## City of Sedona Planning and Zoning Commission Meeting

Tuesday, January 5, 2021

**Staff Report**  
 PZ20-00007 (SUB)  
 Refuge at Sedona  
 Summary Sheet

**Meeting Date:** January 5, 2021  
**Hearing Body:** Planning and Zoning Commission  
**Action Requested:** Review of Conceptual Plat  
**Staff Recommendation:** None at this time  
**Location:** 165 Golden Eagle Drive  
**Parcel Number:** 408-10-060B & C  
**Owner/Applicant:** Simno Holdings LLC (Chris Tortorello)  
 PO Box 4449; Sedona, AZ 86340  
**Authorized Agent:** SEC, Inc. (Krishan Ginige)  
 825 Cove Parkway; Cottonwood, AZ 86326  
**Project Summary:** 12 unit single-family cluster subdivision  
**Site Size:** ± 6.47 acres  
**Sedona Community Plan Designation:** Single Family Low Density  
**Zoning:** Single-Family Residential (RS-18), maximum density: 2 units per acre  
**Current Land Use:** Vacant

**CONCEPTUAL SITE PLAN**  
**CONCEPT 2**

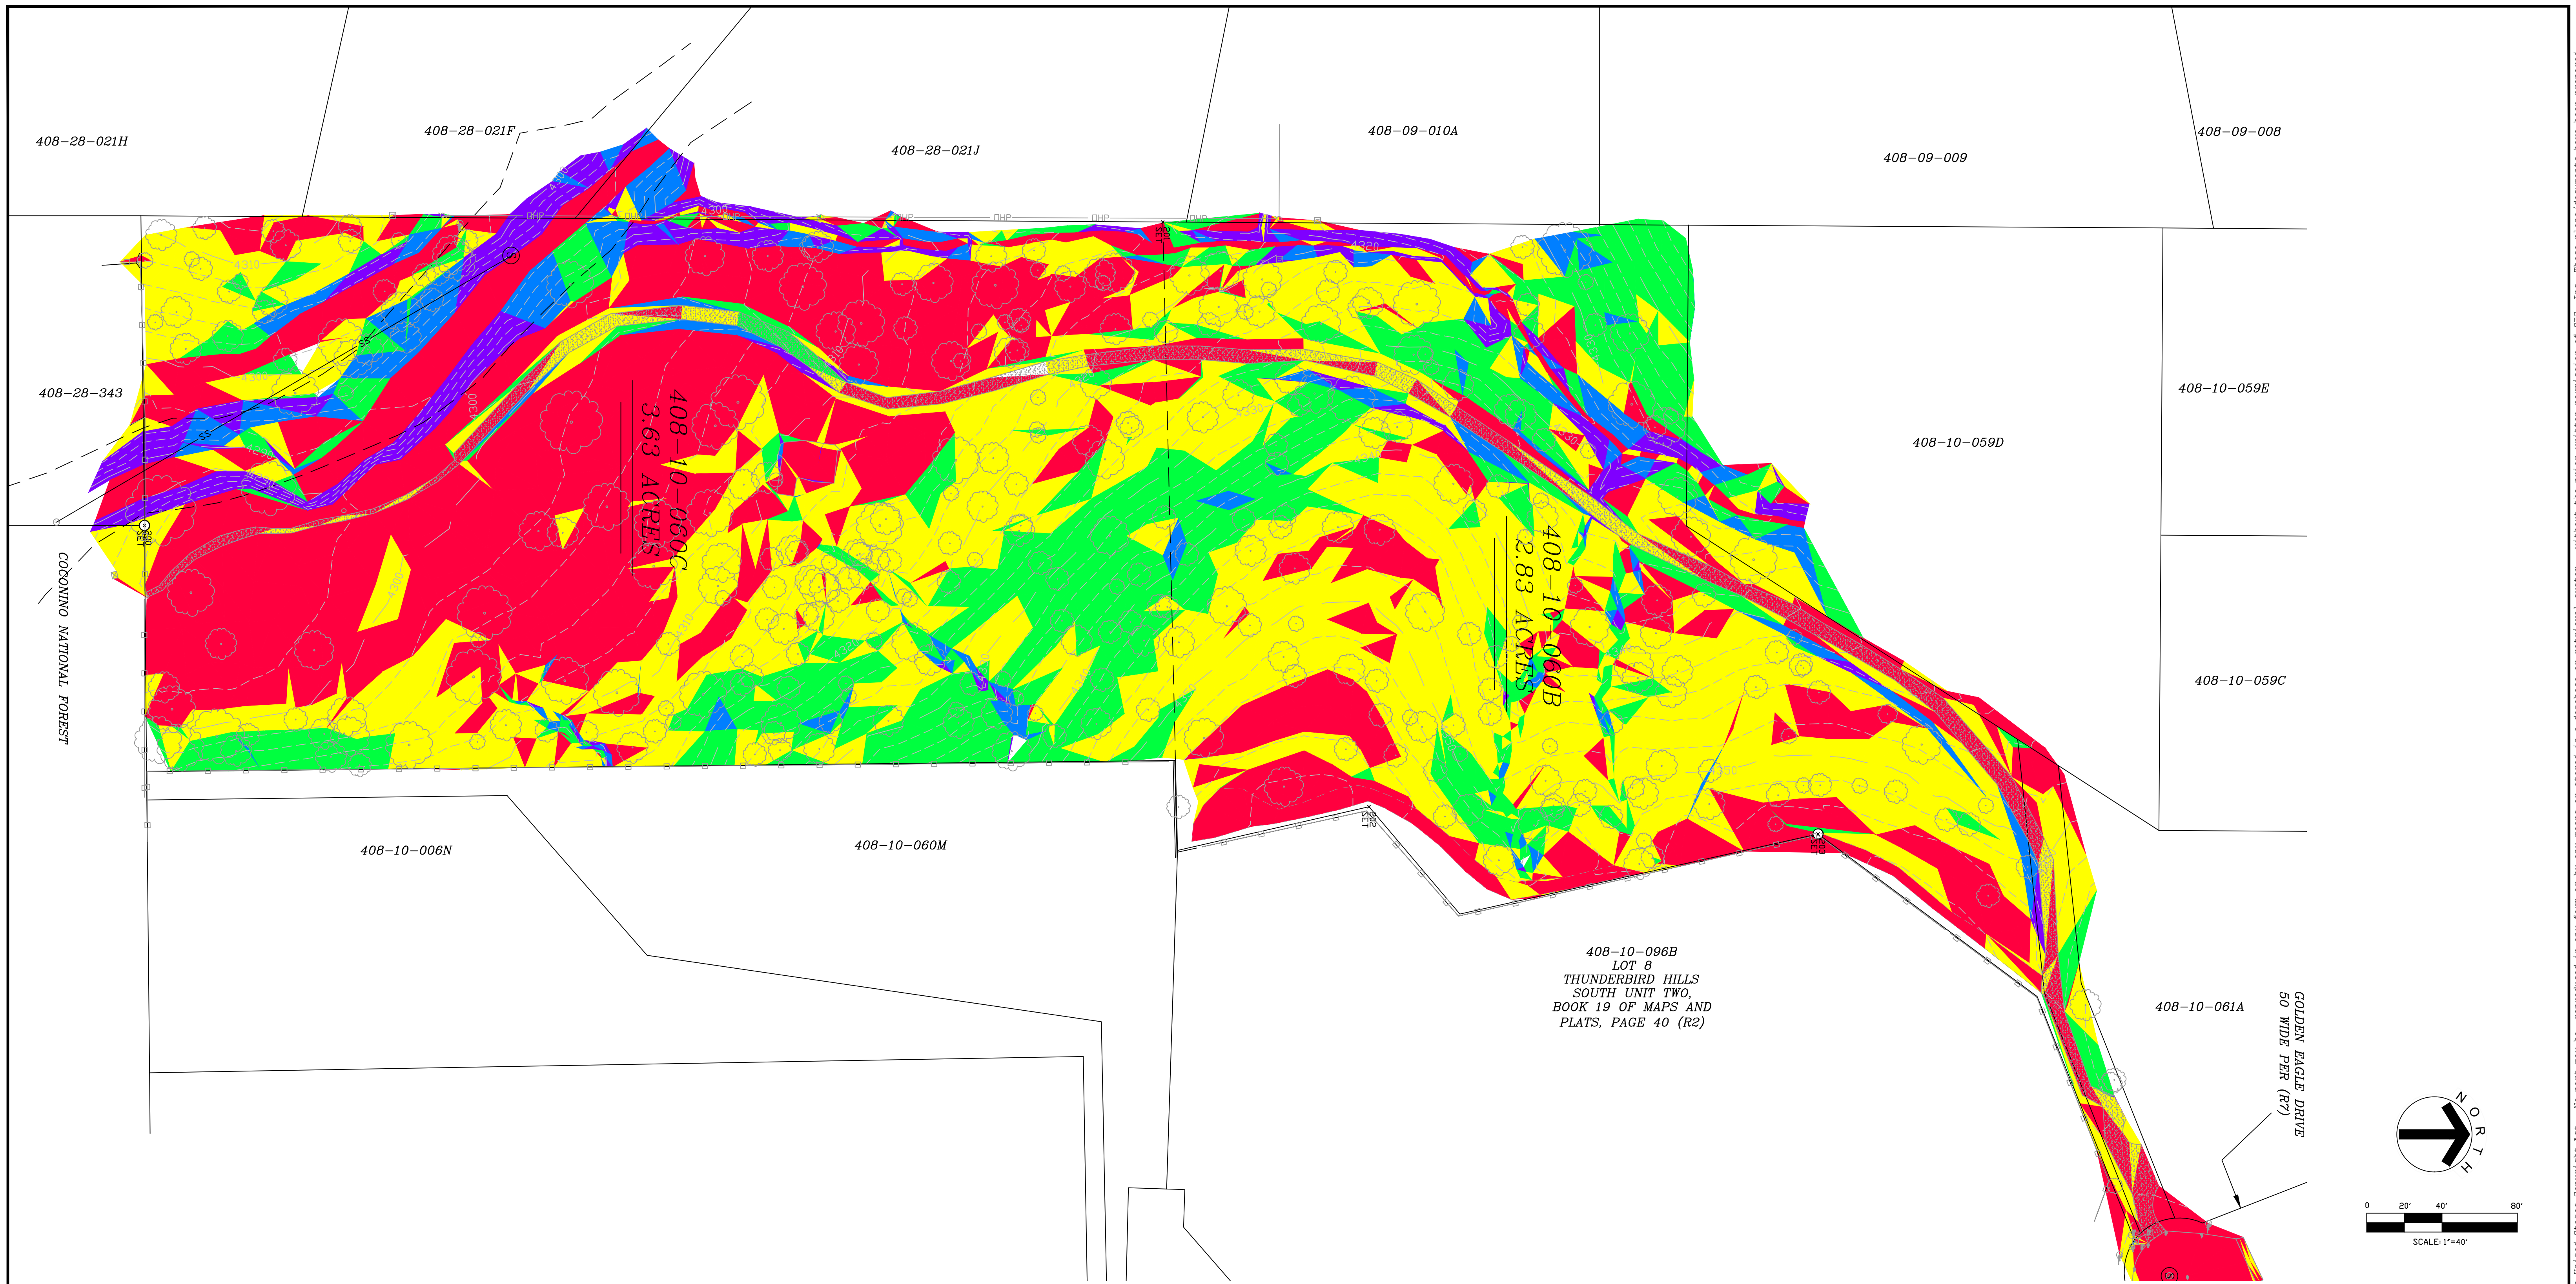
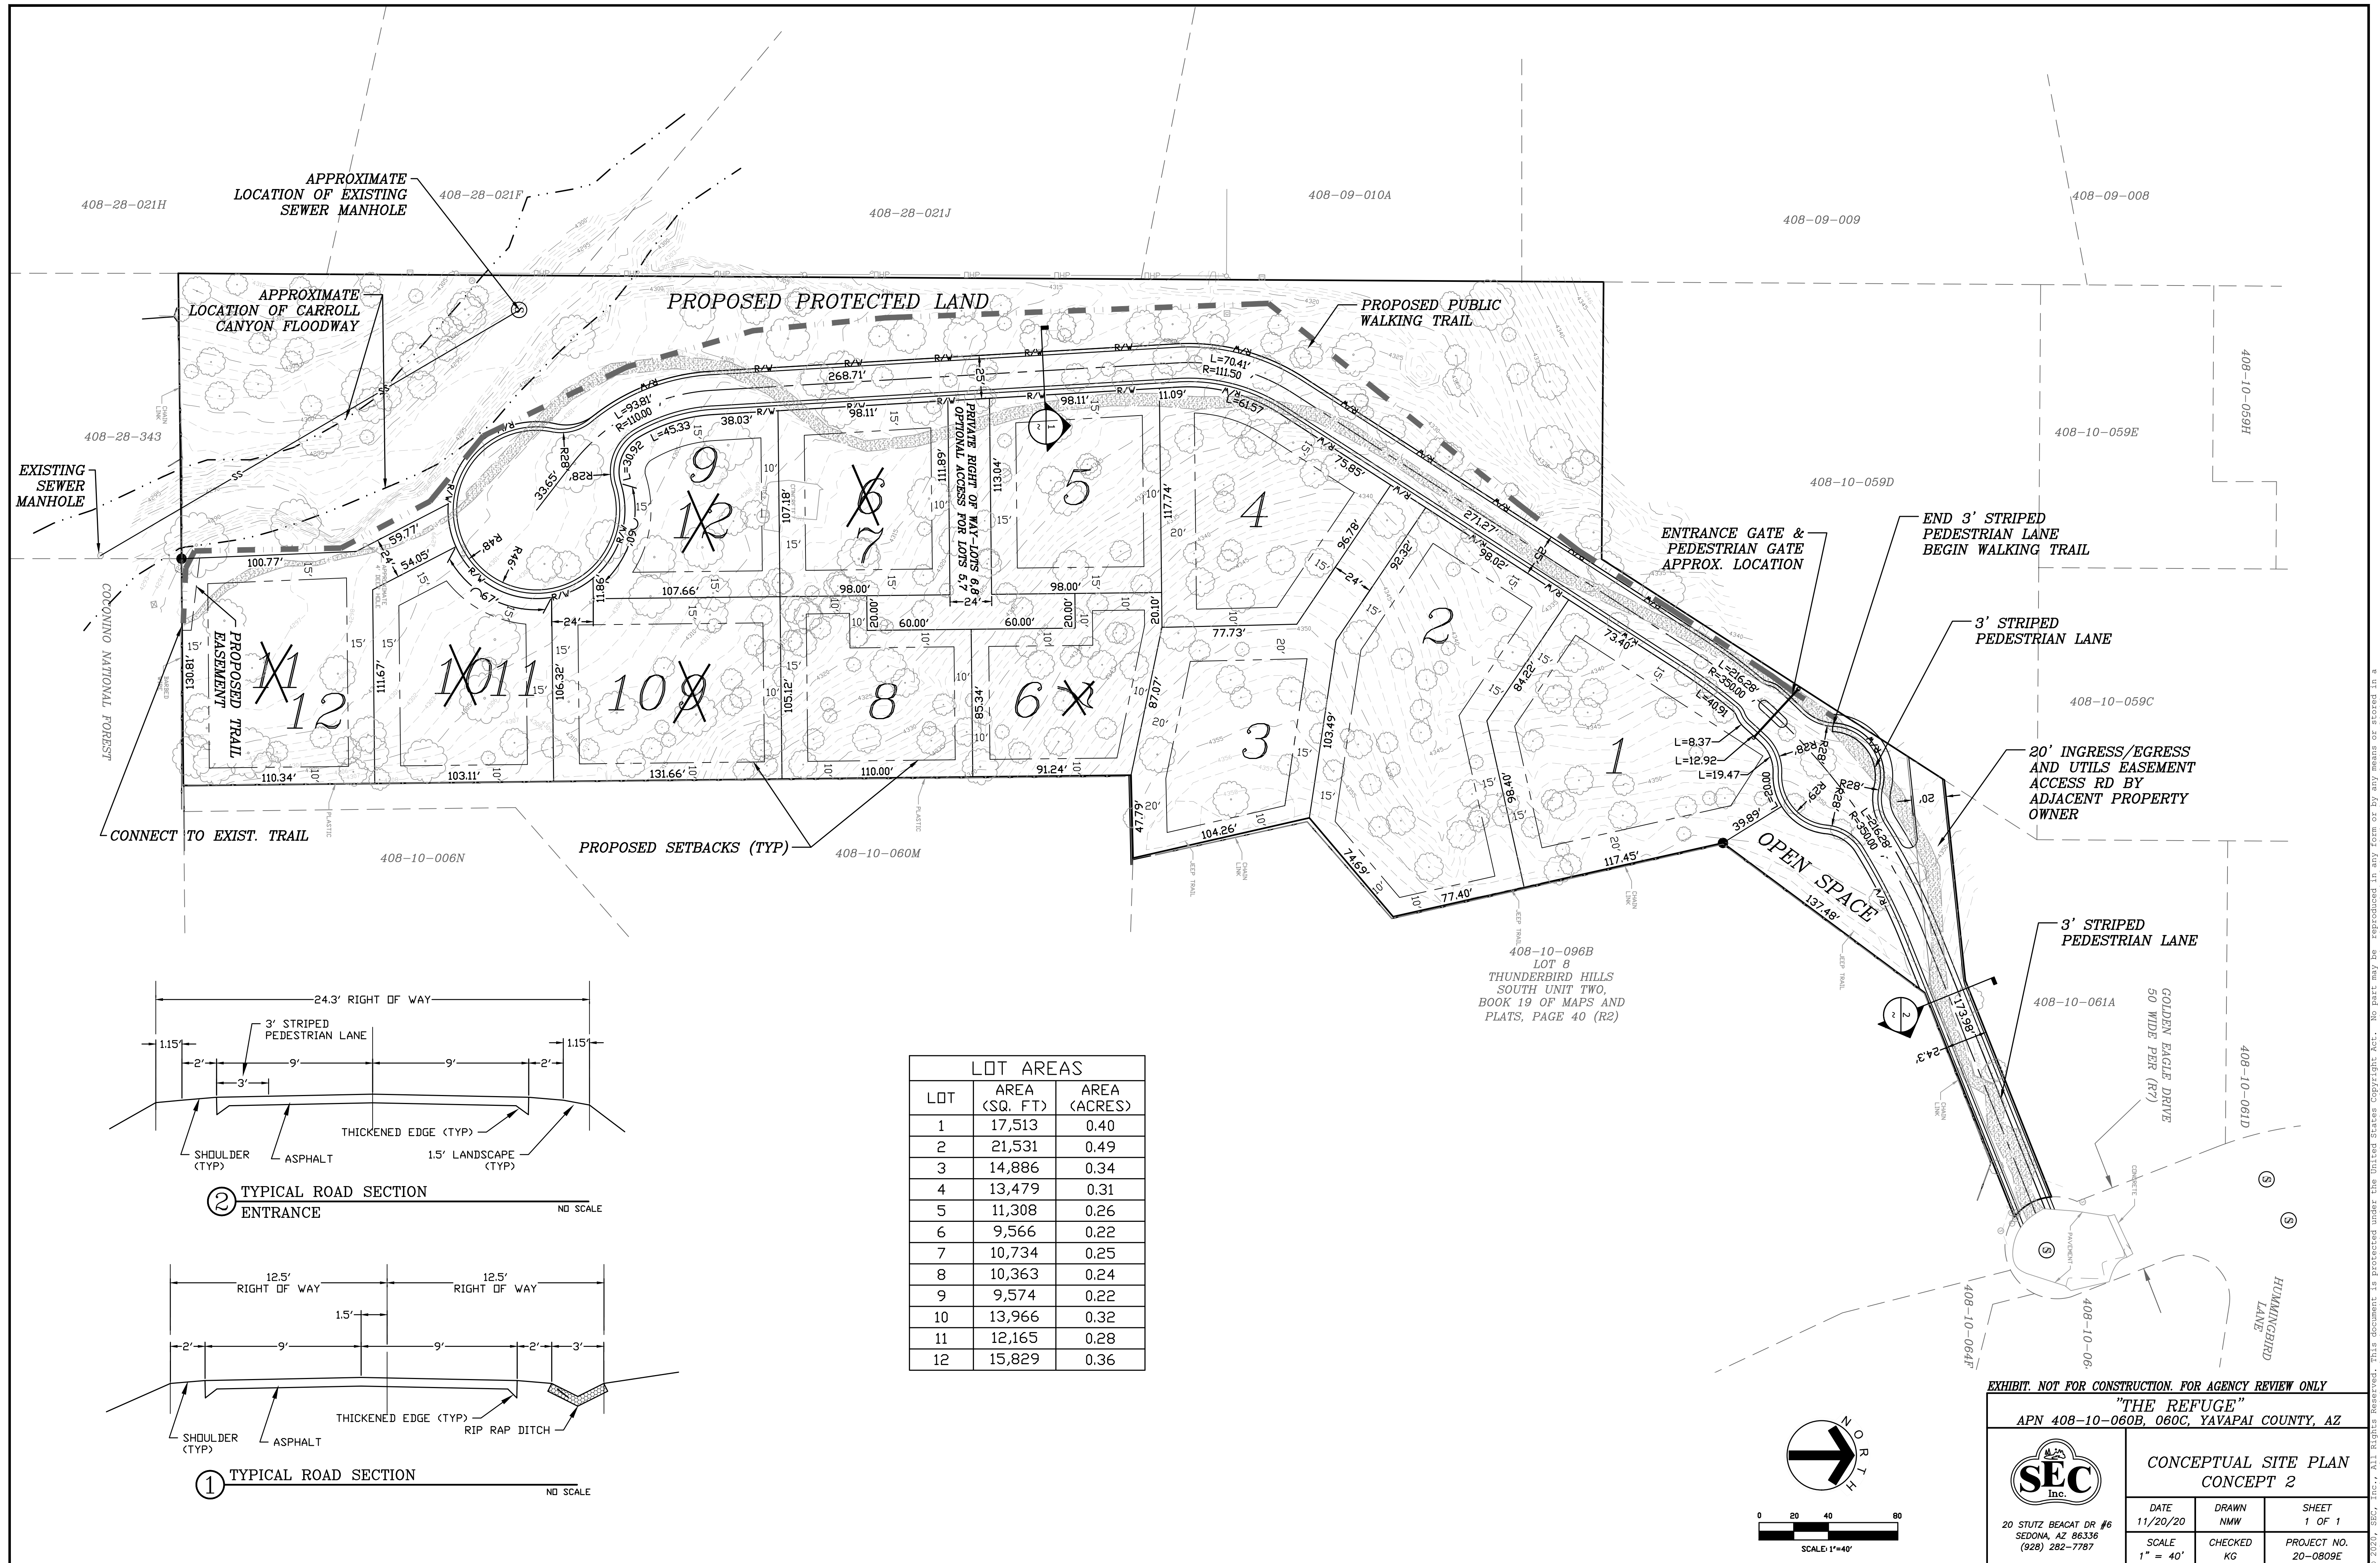
- i) Multiple lots have odd shapes and unusable corners. Revise lot configurations to eliminate these areas/standardize the lot shapes. These lots include:

- iii) Lot 3 and 7: The panhandle in the northeast corner of Lot 7 is unusable and property lines should be adjusted to add that section to Lot 3
  - iv) Lots 7 and 8: Consider modifying the "Y" turnaround for the access for Lots 7 and 8 into a "T" hammerhead. This would eliminate the angles and provide for a more rectangular building envelope when setbacks are applied.

- v) Lot 13: Lot 13 appears to include a long sliver to the north of the lot along the proposed road. The lot line between Lots 13 and APN 408-10-059D should continue to the road easement and the sliver should be added to the Common Area Tract containing the road.

- c) Remove existing property lines from the Preliminary Plat so they are not confused with the proposed lot configuration.
- d) As this application is proposing to subdivide under the clustering provisions, the lots are expected to be smaller than the minimum requirement of 18,000 square feet. Therefore, Staff recommends that the applicant consider designating building envelopes within each lot, as the RS-18 setbacks may be too large for smaller lots. In addition, it is recommended that the applicant clearly delineate front, rear and side setbacks for all lots to avoid confusion in the future.

- e) Clarify how the access to lots 5, 6, 7, and 8 will be designated – private ROW or easement. In addition, specify whether lots 5 and 6 would be permitted/required to take access here.

- f) Clarify the easement to APN 408-10-059D, how that will tie into the proposed new road, and whether any improvements to that area are proposed.

1. Please provide a table with lot information.
2. Please include a narrative of the ownership and maintenance responsibilities for the roadway, shared driveway at lots 6,7,8 &9, and protected land.
3. The previous conceptual plans showed the width of the entry way at 24.2574', but the conceptual plat shows 25'. We have not received a lot line adjustment application from the neighboring properties. Please verify.

15. Please clearly show the ingress & egress & public utility easement. This should be the entire width of the proposed roadway.
16. 18' roadways must have rolled curbs (DREAM Table3.4)

18. Once the roadway widens after approximately 150', adequate pedestrian paths must be provided. Please provide 5' concrete sidewalks on each side of the street, or an 8'-10' shared-use-path on 1 side. The shared-use-path may be asphalt or stabilized decomposed granite but must be separate from the roadway.
